VILLAGE STREETScape PLAN

Goochland County Centerville Village Streetscape Plan **UPDATE**

Village Core

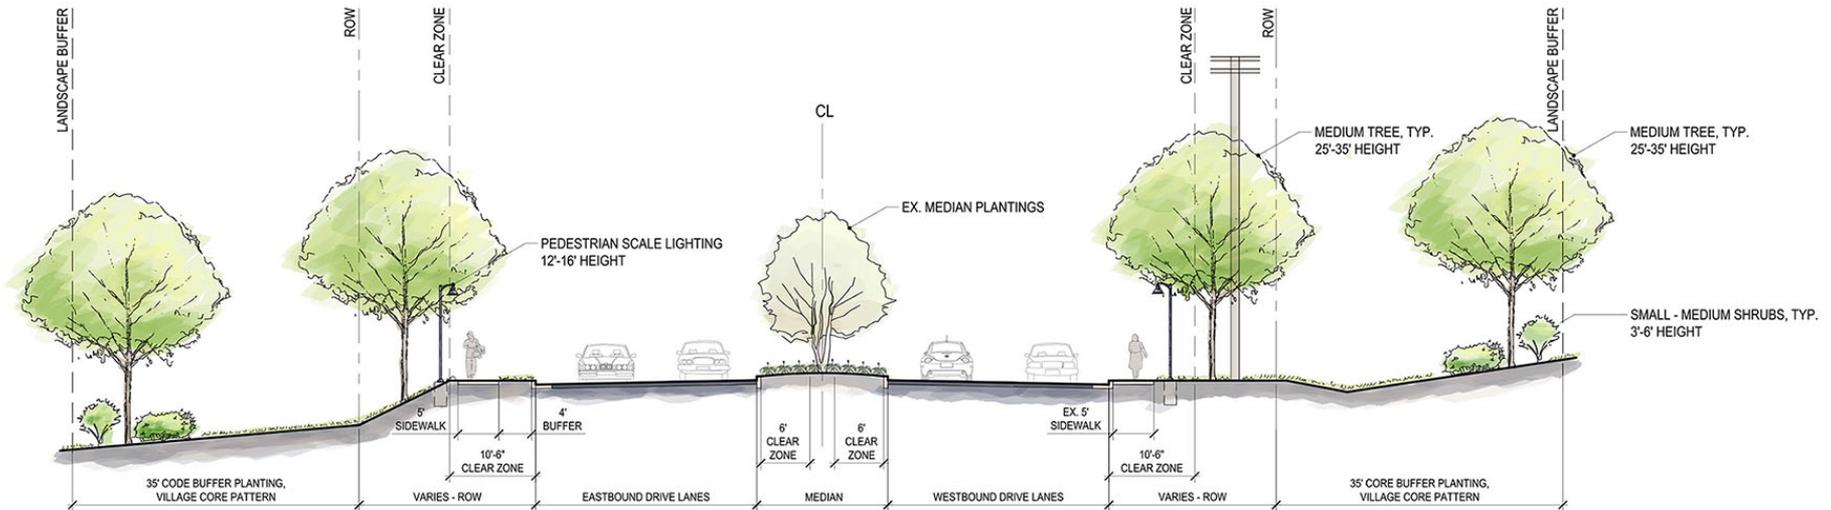
- *No Board Fence Requirement*

Village Core

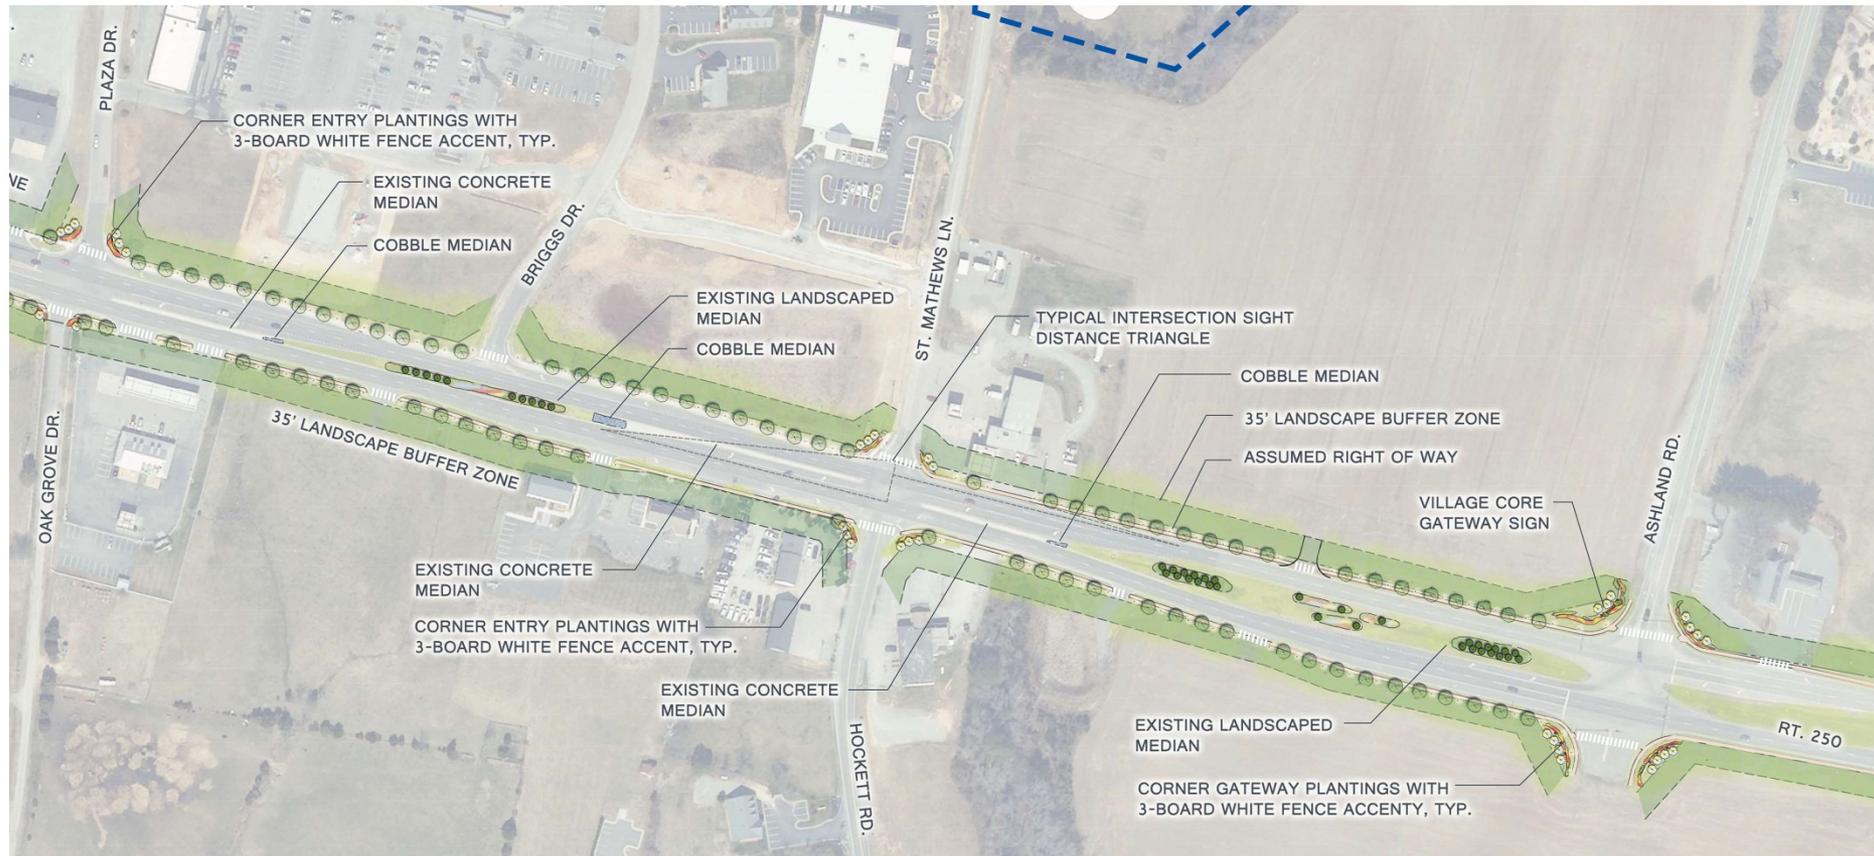
- **No Board Fence Requirement**

PROPOSED CODE BUFFER PLANTING - VILLAGE GATEWAY

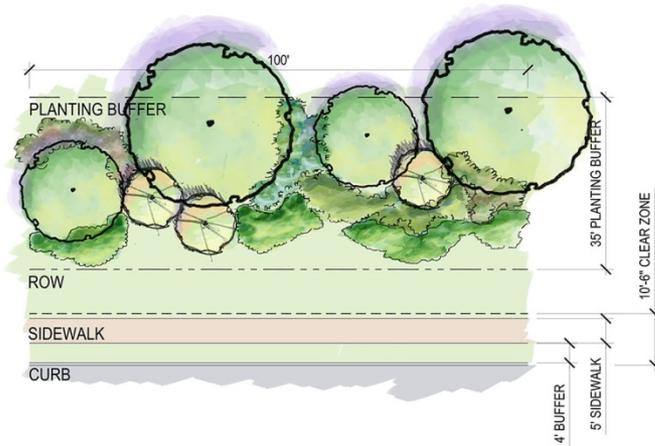
NOTE: SEVERAL EXISTING BUFFERS WITHIN THE VILLAGE GATEWAY DISTRICT APPEAR TO FOLLOW ONLY B-1 ZONING BUFFER REQUIREMENTS, RATHER THAN OVERLAY DISTRICT REQUIREMENTS.

2 TREES/1,000 SF AND 3 SHRUBS/150 SF.

TREES TO BE 50% CANOPY SPECIES (40'-50' MATURE HEIGHT) AND MEDIUM SPECIES (25'-35' MATURE HEIGHT) AND 50% ORNAMENTAL SPECIES (15'-20' MATURE HEIGHT). TREES TO BE 2 1/2" CAL. AT TIME OF PLANTING. SHRUBS TO BE A MIX OF SMALL AND MEDIUM SPECIES (3'-6' MATURE HEIGHT). SHRUBS TO BE 18"-24" AT TIME OF PLANTING. ENTIRE BUFFER SHALL BE MULCHED OR SODDED.

CHARACTER: IRREGULARLY GROUPED ORNAMENTAL AND CANOPY TREES WITH INFORMAL SHRUB MASSING.

Village Gateway

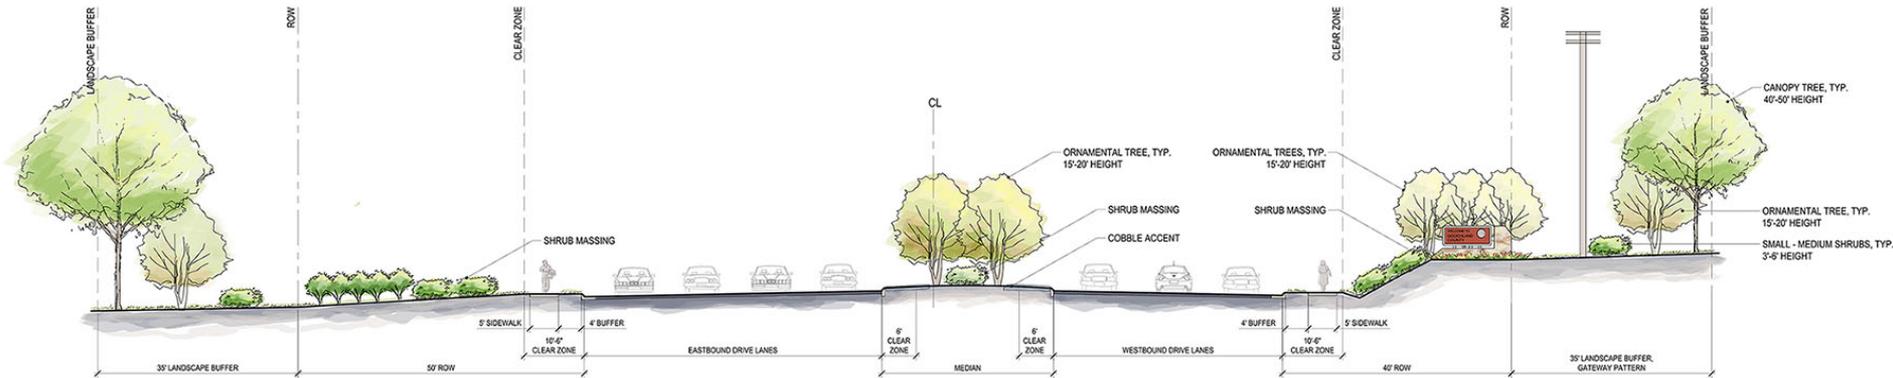
- *Reduced Median Planting Density*
- *Added Cobble Median Accent*
- *Replaced Street Trees w/ Gateway Plantings*

Village Gateway

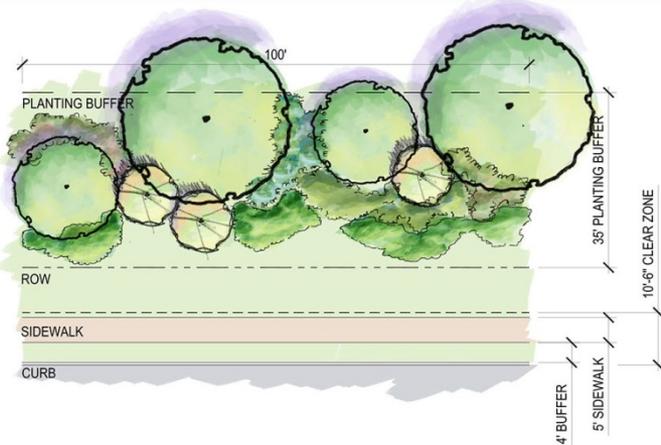
- *Reduced Median Planting Density*
- *Added Cobble Median Accent*
- *Replaced Street Trees w/ Gateway Plantings*

PROPOSED CODE BUFFER PLANTING - GENERAL CORRIDOR

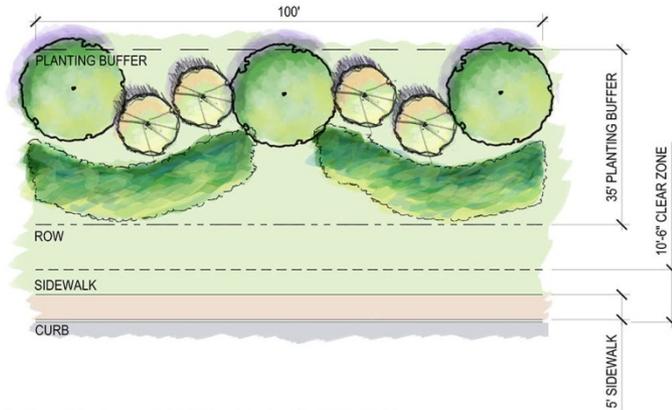
NOTE: SEVERAL EXISTING BUFFERS WITHIN THE VILLAGE CORE APPEAR TO FOLLOW ONLY B-1 ZONING BUFFER REQUIREMENTS, RATHER THAN OVERLAY DISTRICT REQUIREMENTS.

2 TREES/1,000 SF AND 3 SHRUBS/150 SF.

TREES TO BE 50% CANOPY SPECIES (40'-50' MATURE HEIGHT) AND MEDIUM SPECIES (25'-35' MATURE HEIGHT) AND 50% ORNAMENTAL SPECIES (15'-20' MATURE HEIGHT). TREES TO BE 2 1/2" CAL. AT TIME OF PLANTING. SHRUBS TO BE A MIX OF SMALL AND MEDIUM SPECIES (3'-6' MATURE HEIGHT). SHRUBS TO BE 18" - 24" AT TIME OF PLANTING. ENTIRE BUFFER SHALL BE MULCHED OR SODDED.

CHARACTER: IRREGULARLY GROUPED ORNAMENTAL AND CANOPY TREES WITH INFORMAL SHRUB MASSING.

Village General Corridor

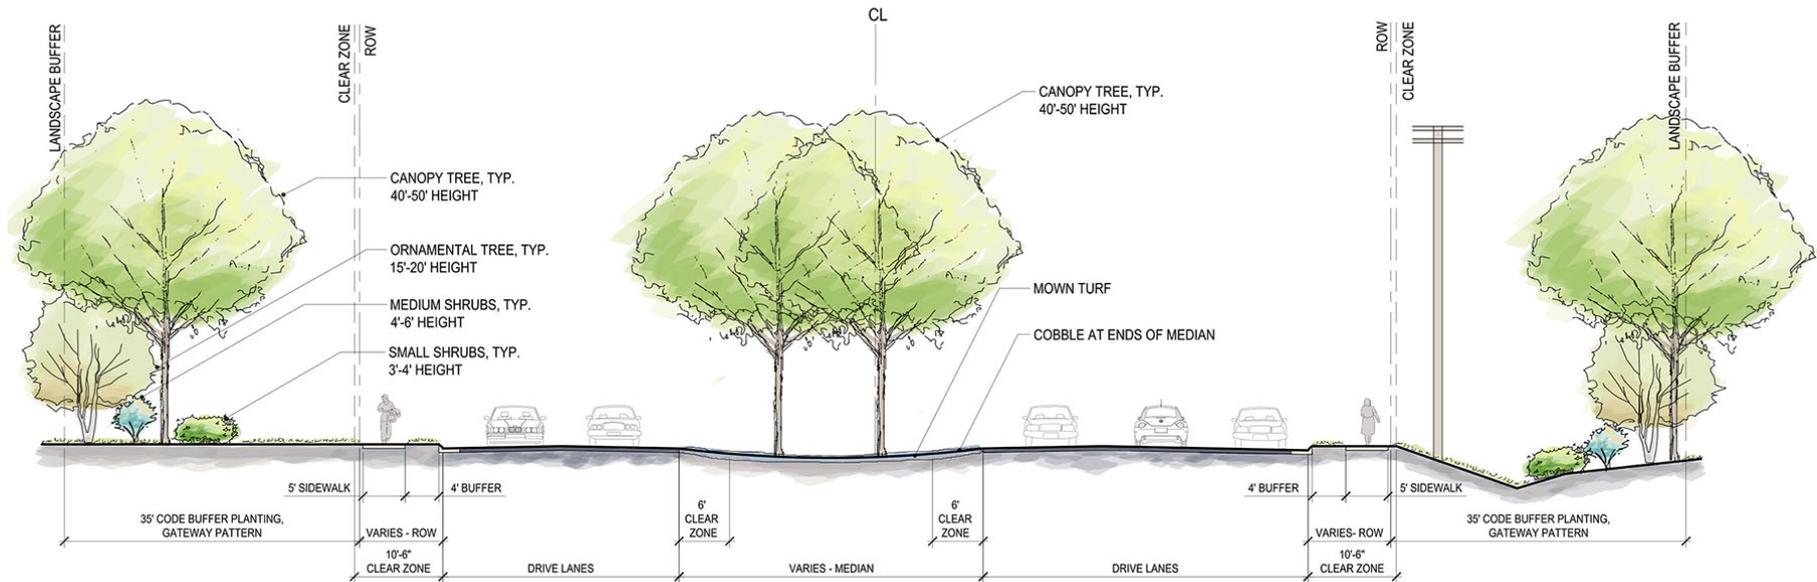
- Changes:**
- **Reduced Median Planting Density**

Village General Corridor

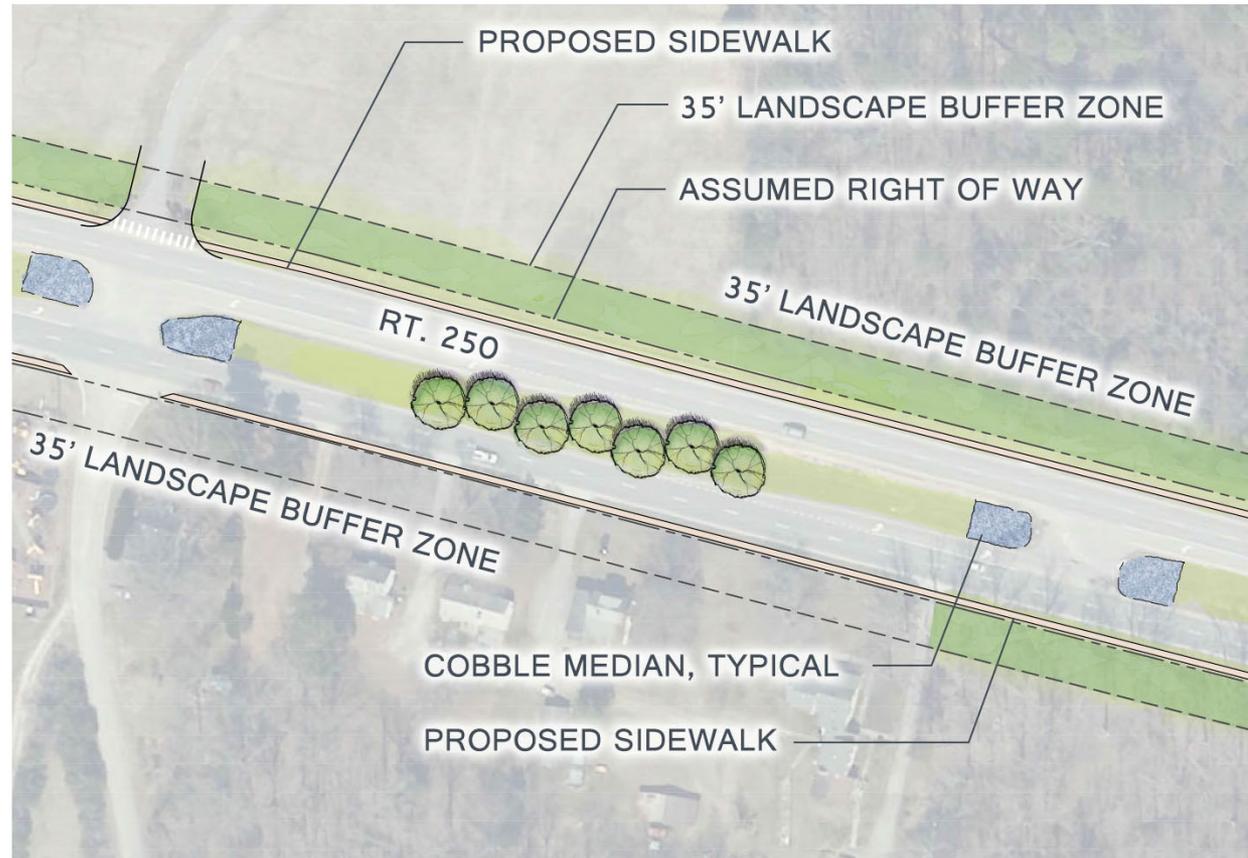
- *Reduced Median Planting Density*
- *Added Cobble Median Accent*
